## Technical Service Bulletin

**16-01-042**

**GENESIS COUPE (BK)**

PASSENGER OCCUPANT DETECTING SENSOR (PODS) UNIT  
CONNECTOR REWORK (RECALL 151)

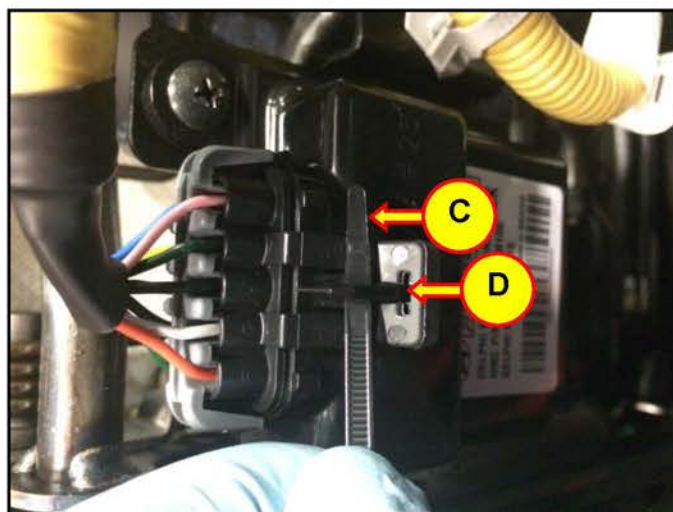
- 6. Locate the PODS unit under the seat.

Confirm the harness is fully seated in the PODS unit.

If the harness is disconnected from the PODS, then reconnect and confirm it is fully seated.

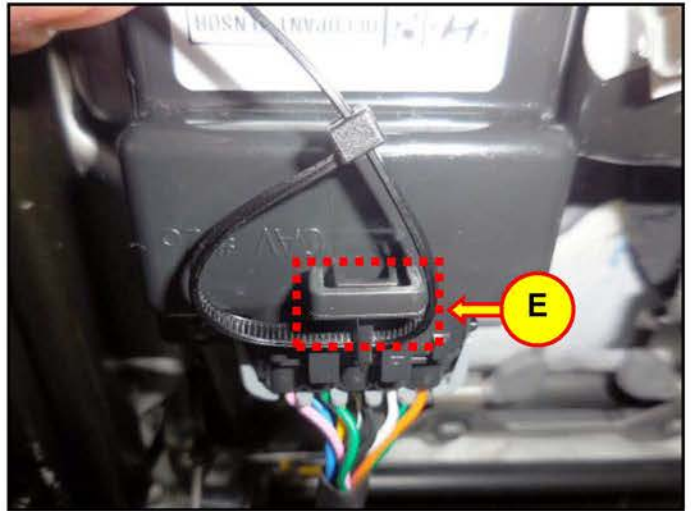
- 7. Insert the cable tie (C) into the PODS unit lock hole (D).

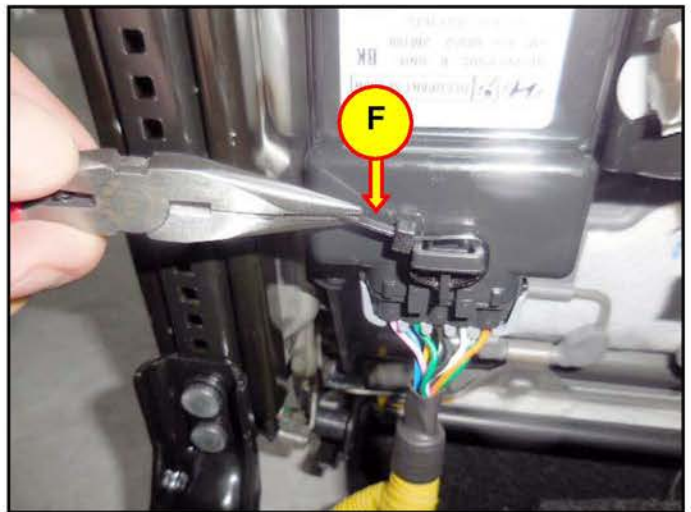
8. Tie the strap around the connector lock side (E).

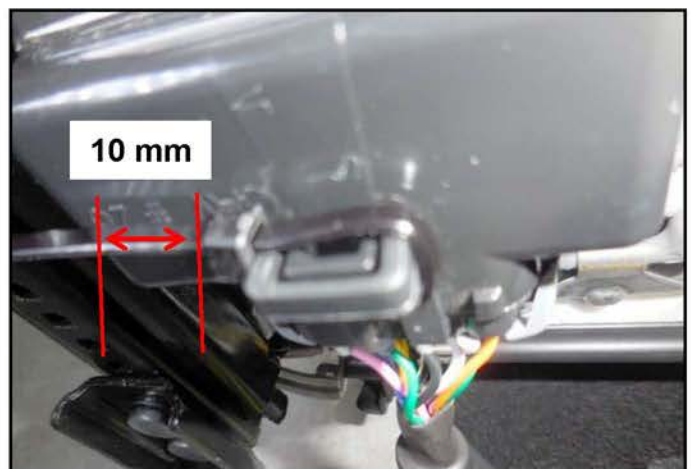
9. Tie the strap (F) tightly.
